Subject: Department of Energy/National Nuclear Security Administration, Sandia National Laboratories/New Mexico – Solid Waste Management Unit 52: Filling Tanks 2 and 4 with a Permanent Insoluble Material

Solid Waste Management Unit (SWMU) 52: Filling Tanks 2 and 4 with a Permanent Insoluble Material

September 2013

Tank 4 & Tank 2 Closure In Place July 2013

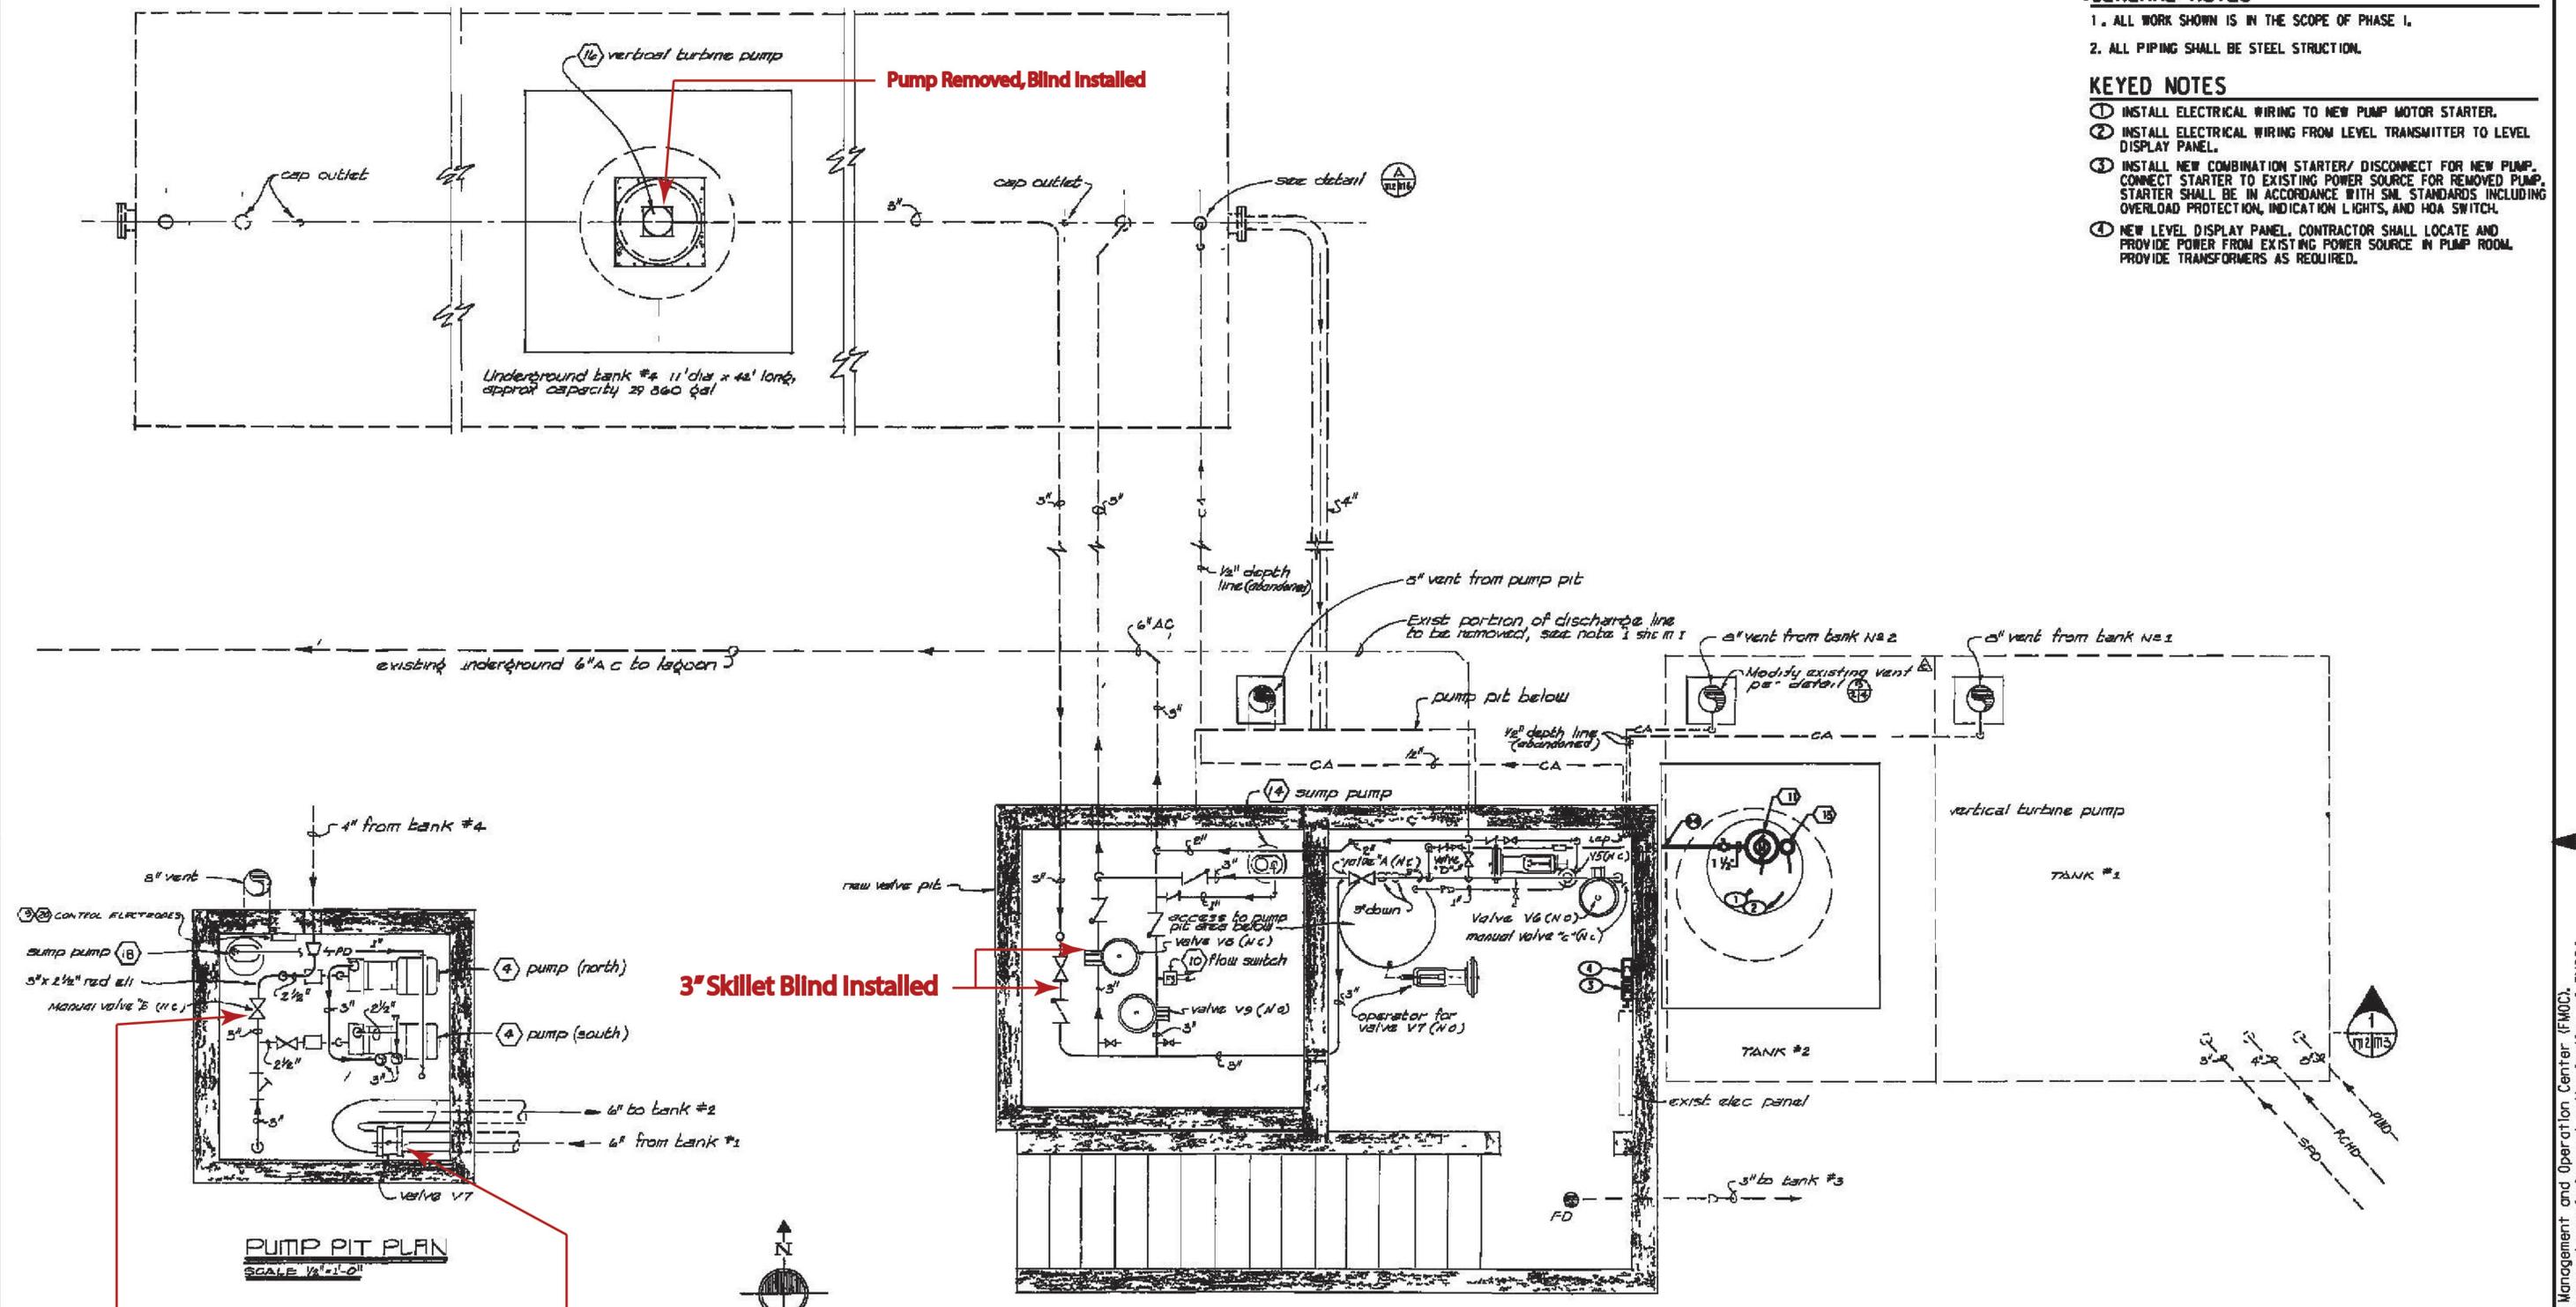
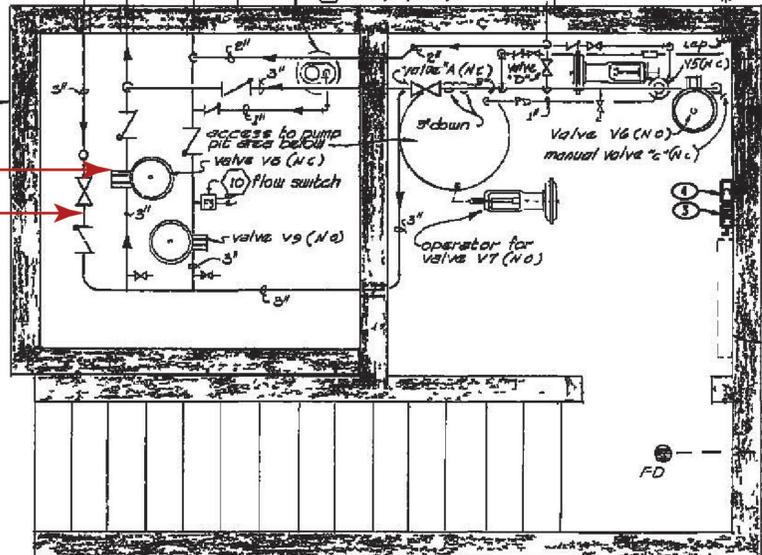
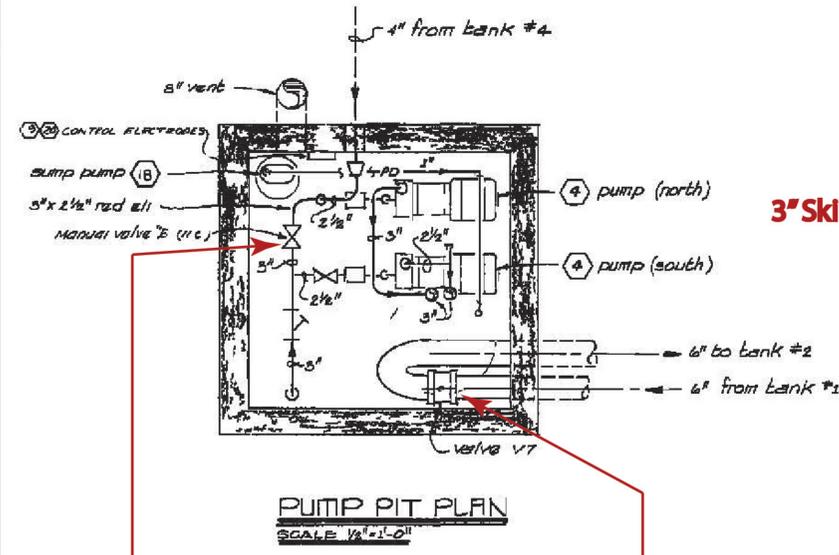
2" Skillet Blind Installed

2" Skillet Blind Installed

3" Skillet Blind Installed

11/02	INSTALL NEW PUMPS (4) & (16)	CEC	CFM
7/08	REMOVE PUMPS (4) & (16)	BAA	
4/09	Remove pneumatic Control System	COM
